Change Order Memorandum

Project Name	Margate Boulevard Crosswalk and Landscape Improvements			
Date	1/6/2026	Change Order No.	2	Project No. 21-0089.00012
Contractor	FG Construction

Project Name: Margate-Crosswalk and Landscaping Improvements

CO No.: CO002

Location: Fire Station driveway.

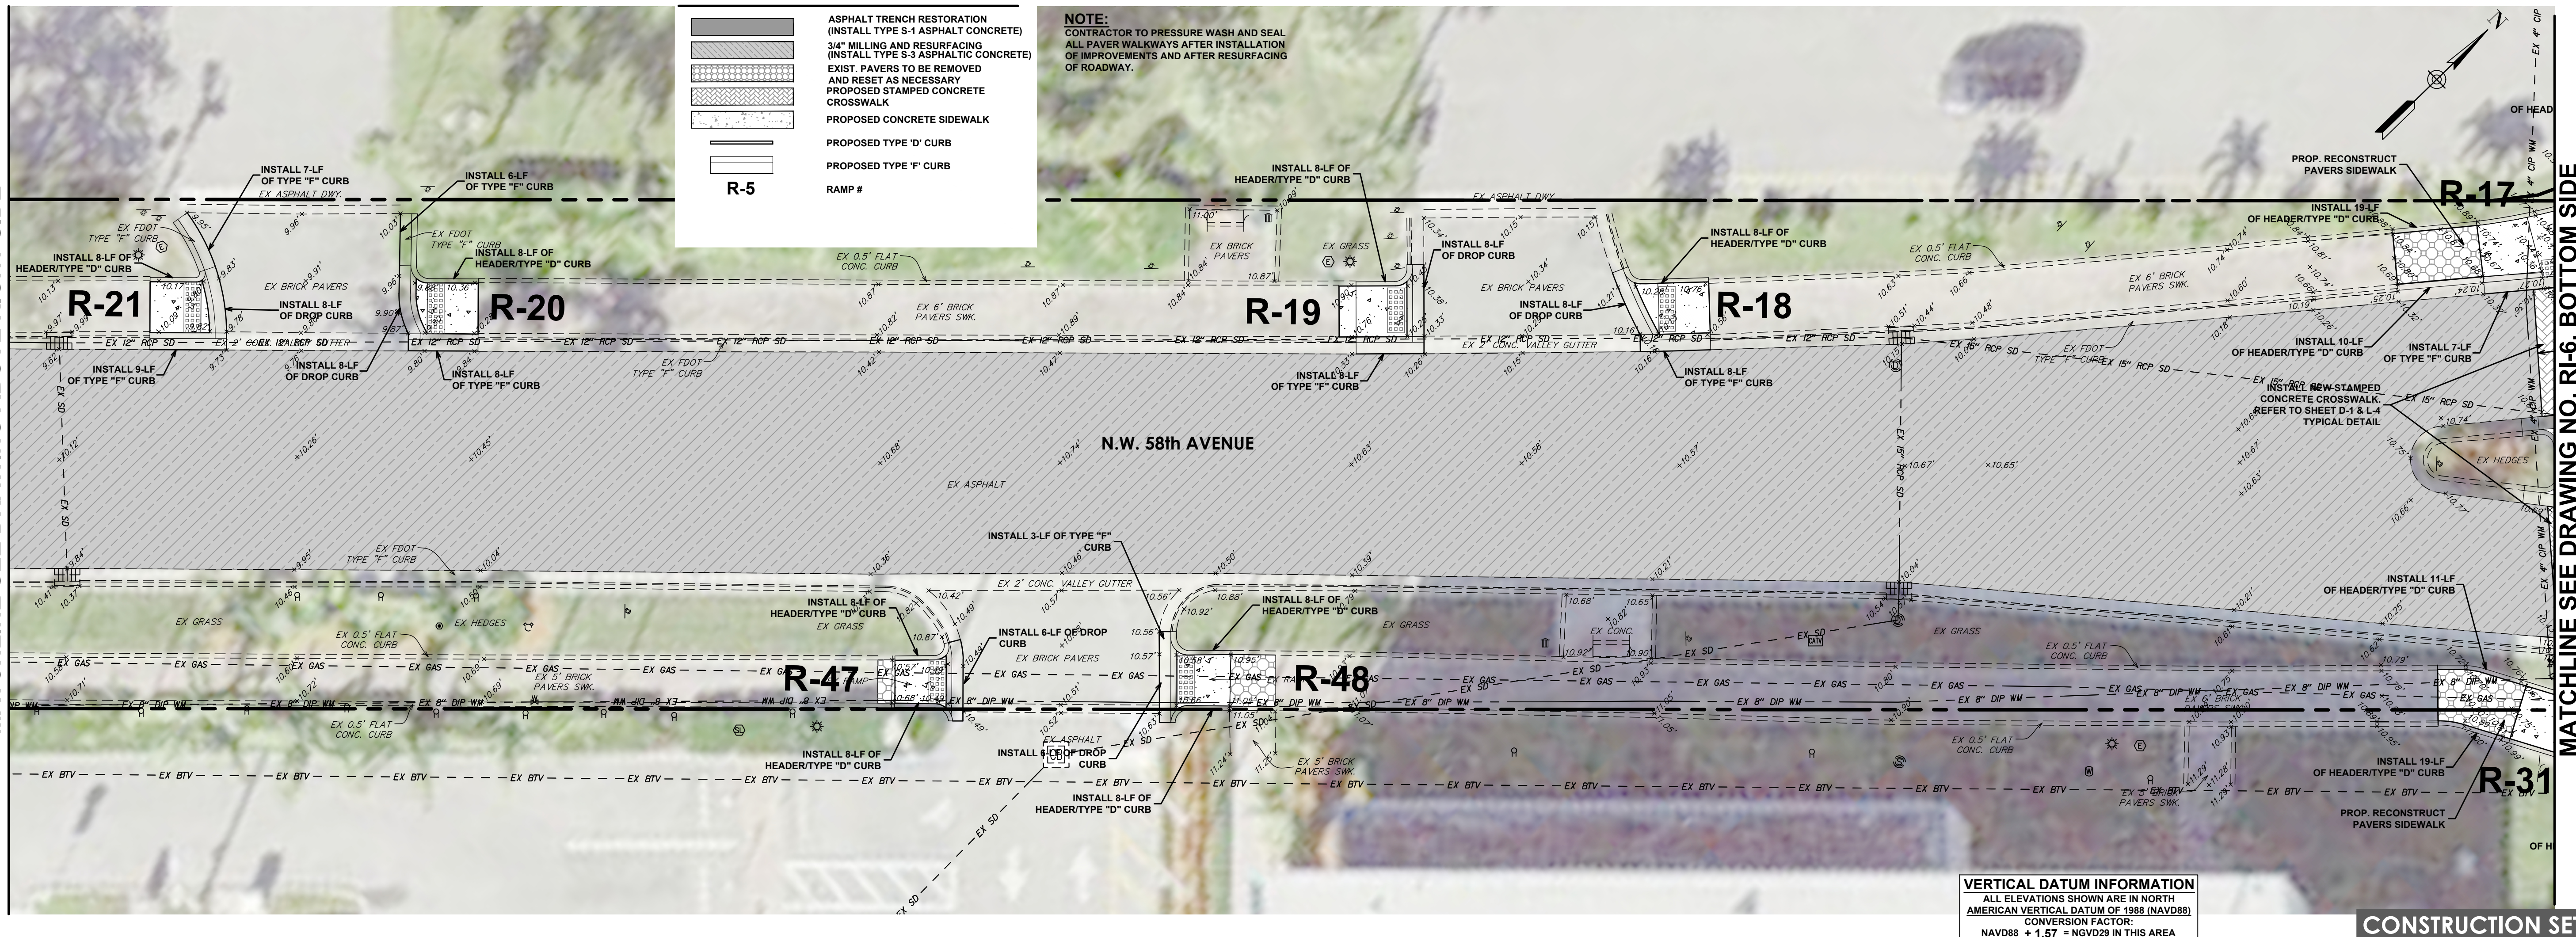
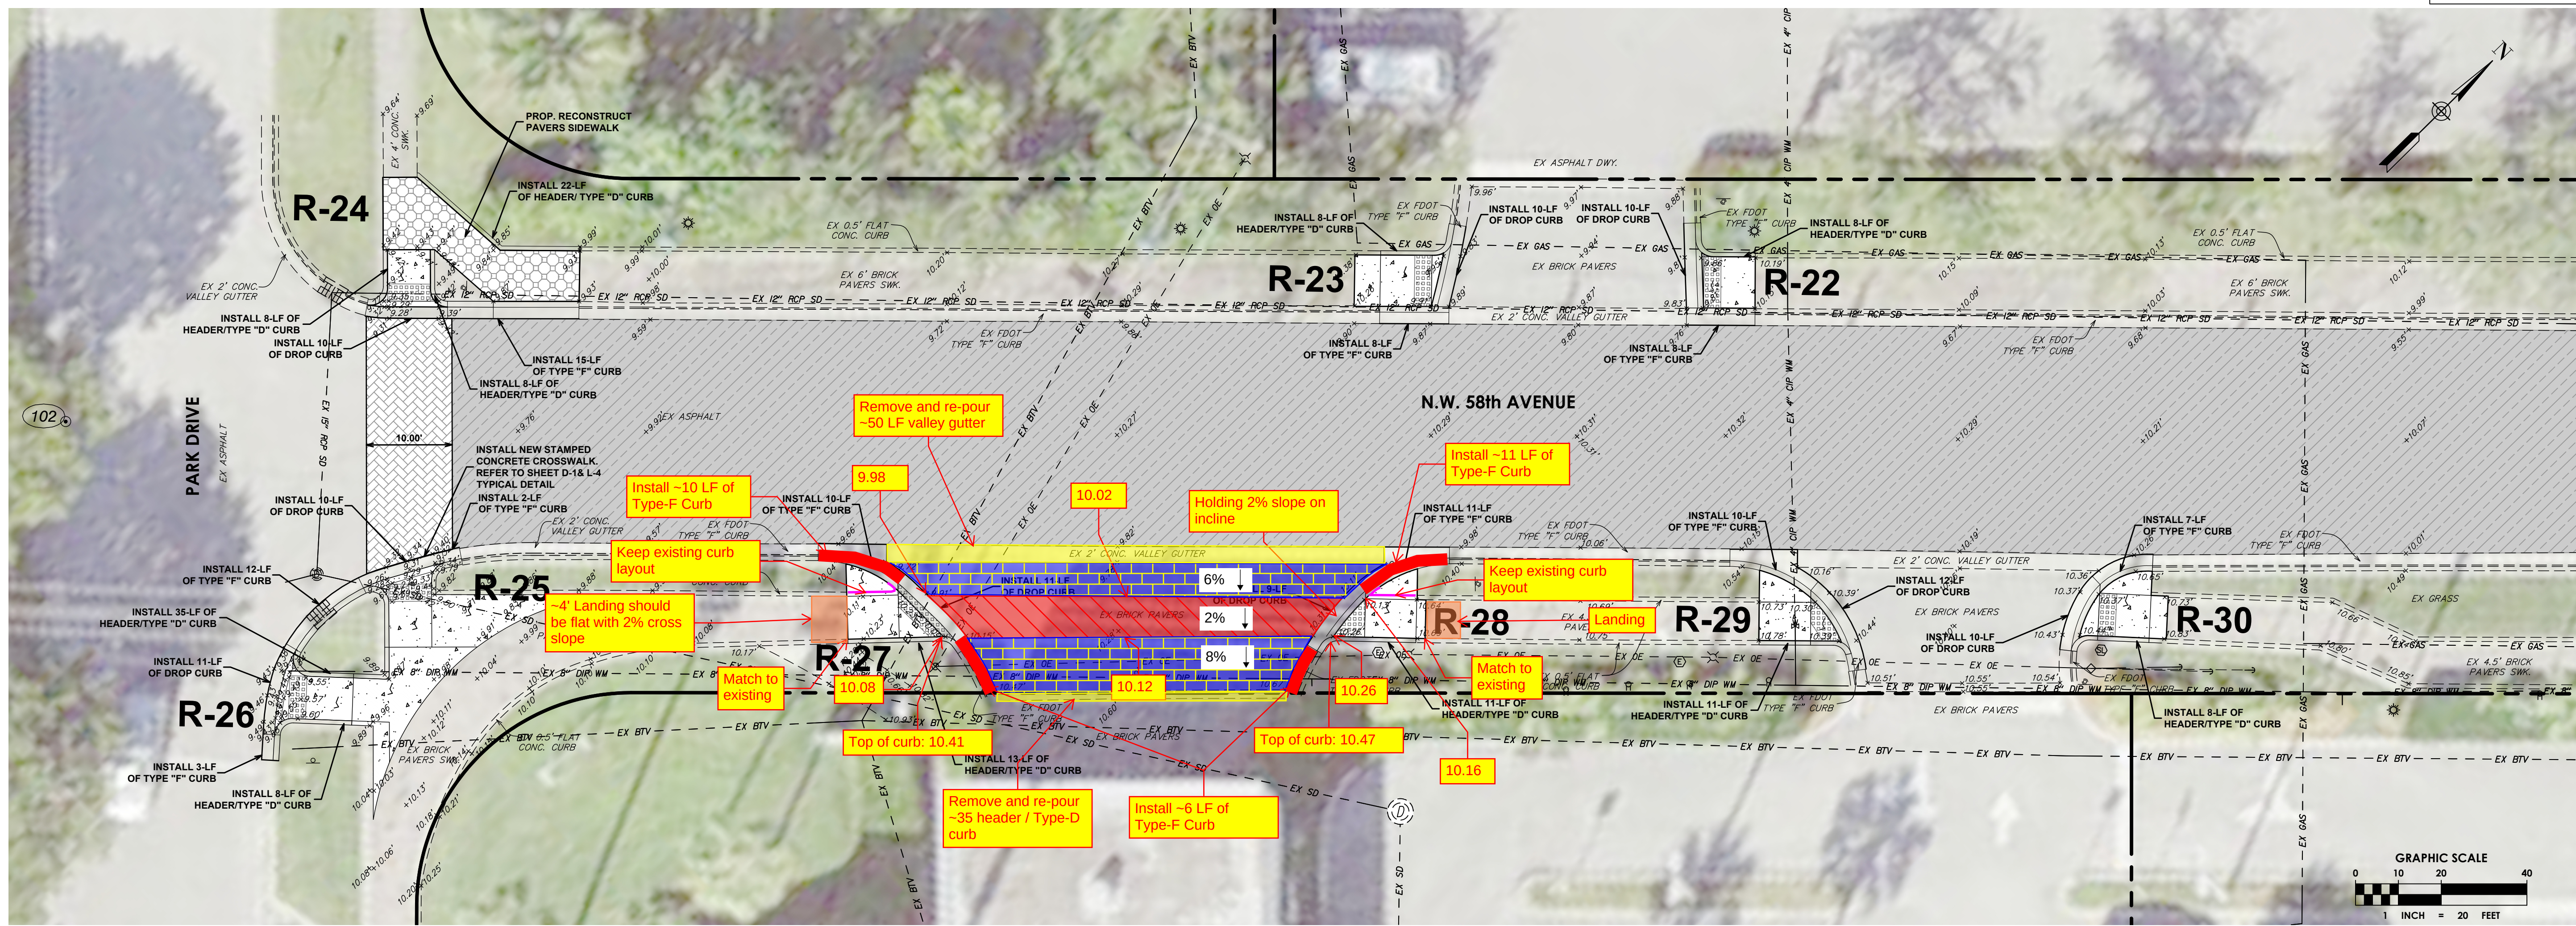
Existing conditions at ramps R-27/28 and its driveway are showing signs of deformation/settlement due to prolonged exposure to heavy traffic loads. Cracks are apparent in the adjacent valley gutter, and the maximum of a 2% cross slope is currently exceeded.

Contractor to remove existing paver driveway between ramps R-27/28. Regrade the subgrade to reflect a 6% cross slope from the valley gutter to the proposed crosswalk, a 2% cross slope across the crosswalk, and an 8% cross slope from the crosswalk up to the header curb of the fire station. Remove and repour header curb.

Additionally, the contractor is to remove and repour the existing valley gutter which is showing signs of distress. Approximately 55 LF of valley gutter, 35 LF of header curb, and 72 SY of pavers to be restored.

Scope: Remove existing pavers and curbs. Regrade subgrade and base. Repour curb and install pavers.
